# Memorandum

SUB-2017-74 AND LUC-2017-407: 34 GORMAN STREET,

MACANDREW BAY. COMMENT FROM LANDSCAPE

ARCHITECT.

## 34 Gorman Street, Andersons Bay. Submission 0487.1

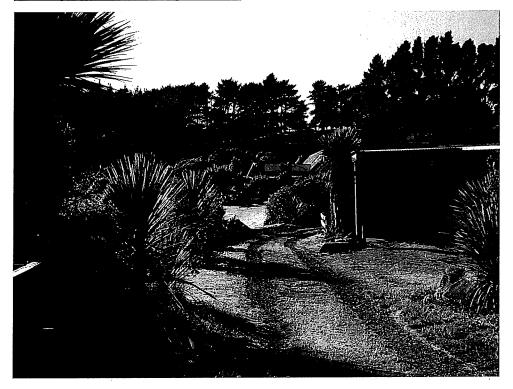
In terms of visibility the site is moderately sloped compared with further up the peninsula, and reasonably well screened by existing lower dwellings. However, there are some important natural values associated with the site, as recognised by its Significant Natural Landscape overlay zone. On balance it is my opinion that the proposed retention of the 2GP Rural Hill Slopes zone is appropriate here.
